AMENDMENT (SWG-2012-00602)

BERTHS 2 AND 3  
 COVER SHEET  
 TEXAS INTERNATIONAL TERMINALS  
 GALVESTON, TEXAS

The applicant is requesting to amend their current U.S. Army Corps of Engineers (USACE) Permit SWG-2012-00602 that is authorized through December 31, 2019 for development of a proposed berthing facilities within an existing basin in Galveston, Galveston County, Texas (the Project). In an effort to reduce the footprint of Project components and streamline dock design for safely mooring Aframax and Suezmax vessels, the amended design will include: 1) construction of a streamlined berthing facility; 2) construction of a steel sheet pile retaining structure/breakwater for berthing dock facility support and associated concrete riprap for slope stabilization; 3) construction of a separate combi-wall bulkhead to replace the existing concrete bulkhead and riprap for shoreline and rail loop protection, including placement of clean fill material within a 0.67-acre unvegetated open water habitat behind the combi-wall bulkhead; 4) dredging of an 33-acre unvegetated open water area adjacent to east of the proposed berthing facility to a minimum depth of -45-feet Mean Lower Low Water (

BERTHS 2 AND 3  
 AMENDED DOCK PLAN  
 TEXAS INTERNATIONAL TERMINALS  
 GALVESTON, TEXAS

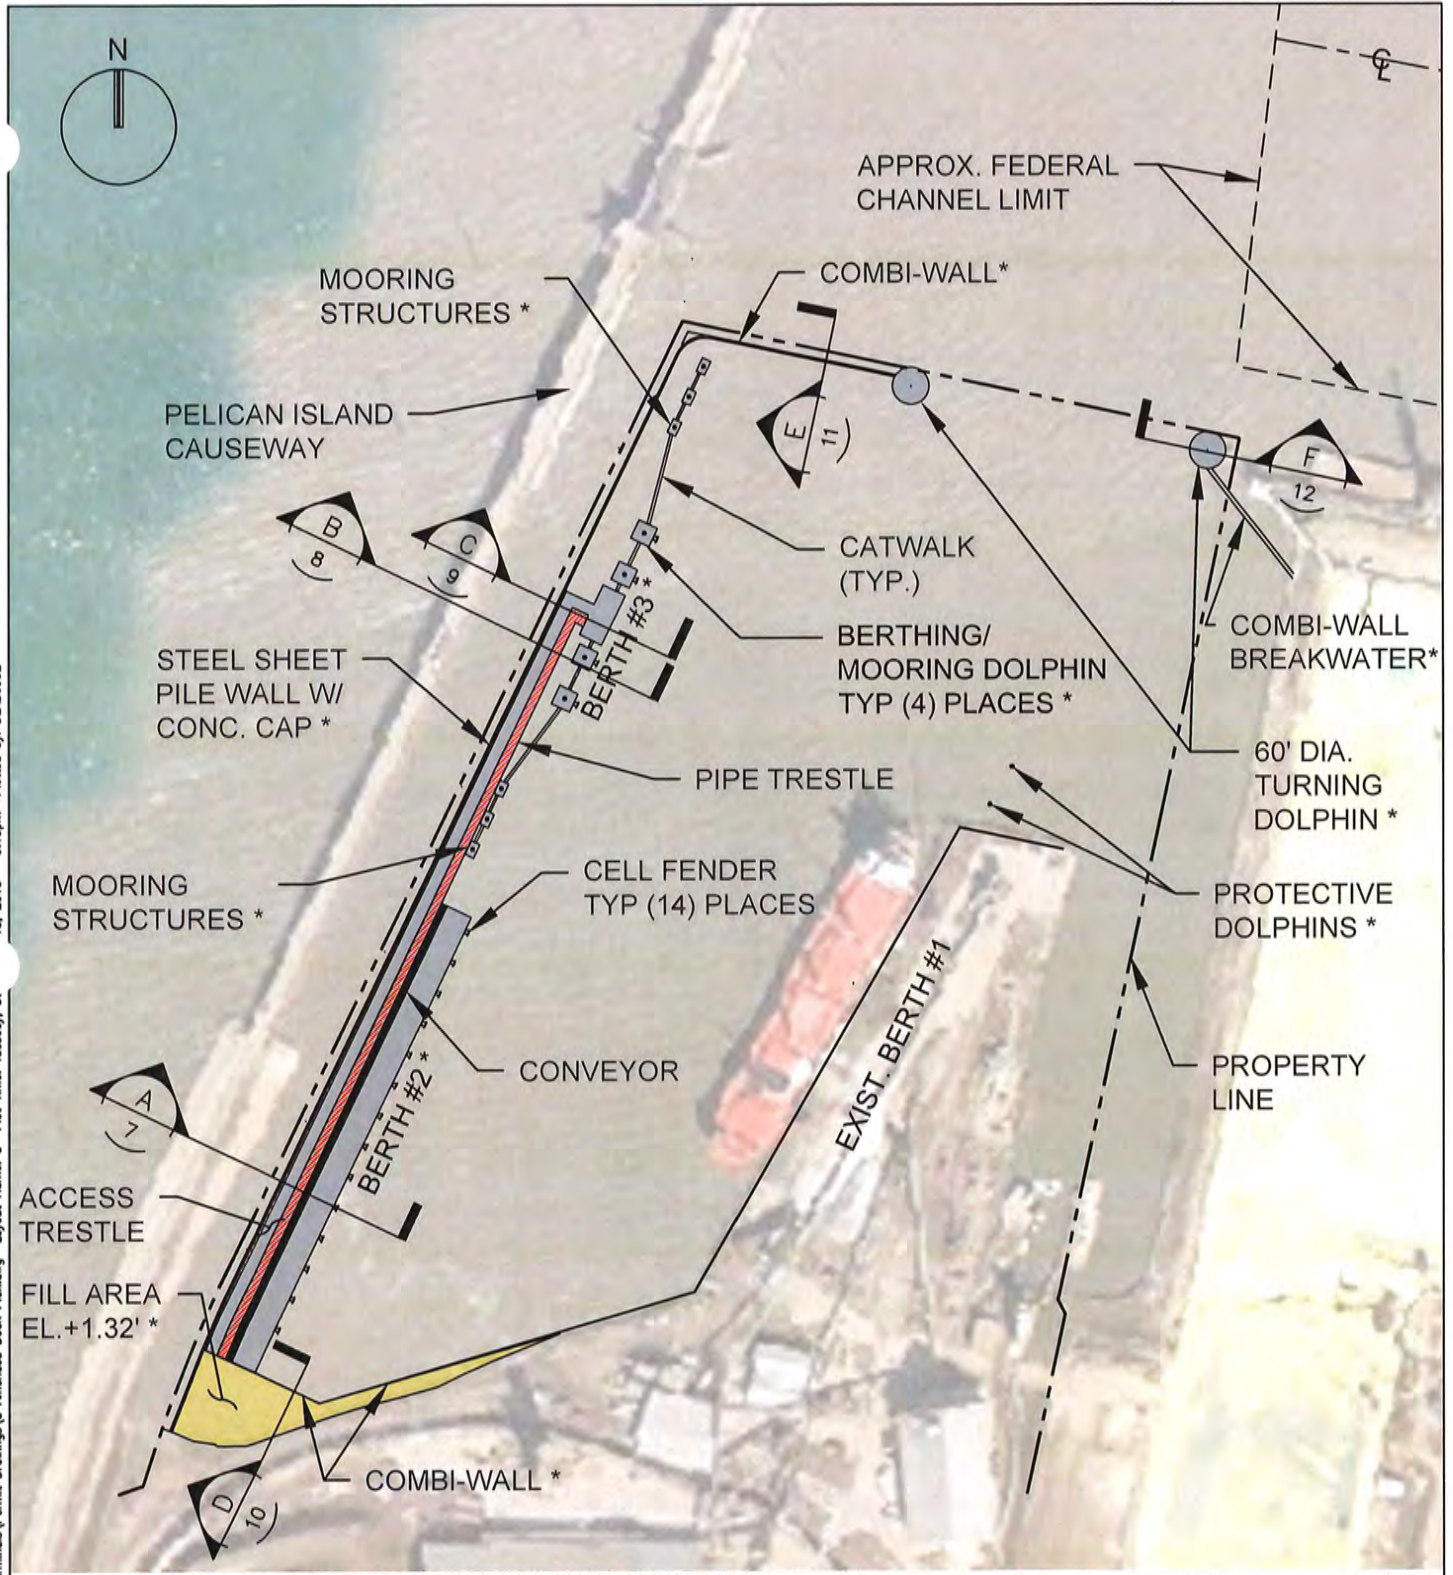
\* PREVIOUSLY AUTHORIZED  
 STRUCTURE/FILL STREAMLINED FOR  
 BETTER SHIP ACCESS AND SAFETY  
**AMENDMENT (SWG-2012-00602)**
